VOX Treble Booster

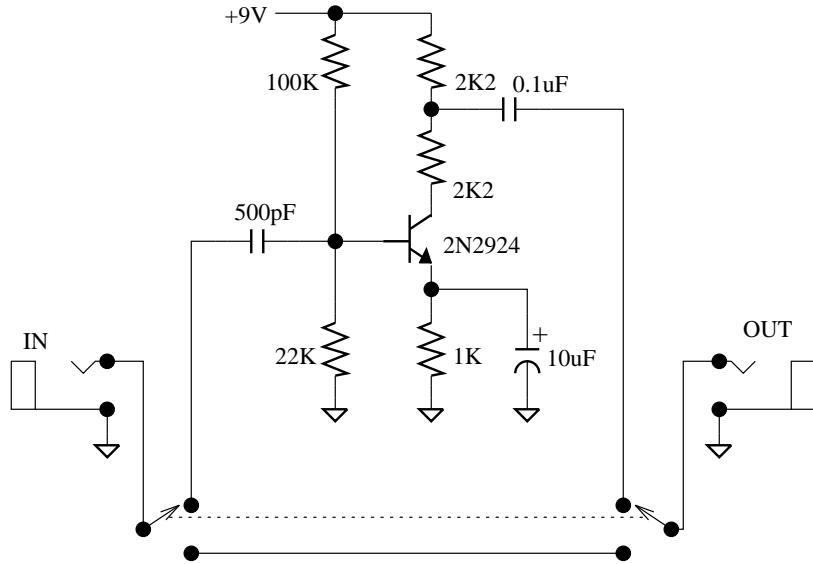
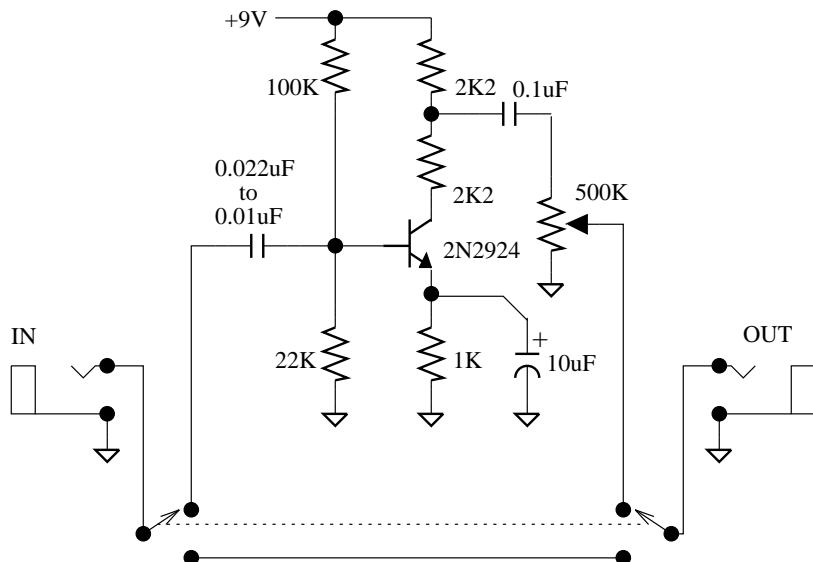
Modified to be used as an overdrive/distortion unit

The input cap is changed from 500pF to 0.01 uF (1000pF) or 0.022 uF (2200 pF) to allow more bass in. This usually overloads the booster and causes crunchy distortion.
